Technical Bulletin

Cylinder head

L 1700 L 2000

42.1

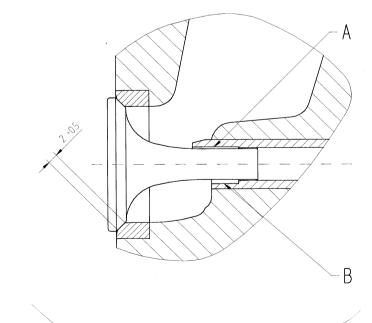
Due to changing fuel recipies, problems with burnt exhaust valves were observed. An investigation showed that increased combustion deposits are responsible for the problem. This has been reported from other engine manufacturers as well. The deposits lead to valve sticking in the lower countersunk area of the exhaust valve guides (see section A in the sketch below). The time span until problems occur depends on the type of aircraft, the condition of the cooling baffles, operating mode of the aircraft, the fuel brand and the engine oil used. Specific brands of fuels cannot be recommended, because thier recipies may change locally. The frequency of occurrence is higher with engines which are stressed higher than normal.

before mod.

after mod.

The exhaust valve guides are milled until flush with the material of the exhaust port. The remaining rest of the countersunk area is enlarged to 9.5 mm diameter. The bottom of the countersink must be perpendicular to the main bore with a sharp edge. This way the ring area around the valve stem is enlarged and the shoulder at the end of the countersink will prevent deposits from entering the valve guide bore. In addition to this measure the with of the sealing face on the valve seat is cut to a width of 2 mm. This should contribute to a reduction of the valve temperature. Replace exhaust valves with new ones. Check condition of cooling baffles and replace if necessary.
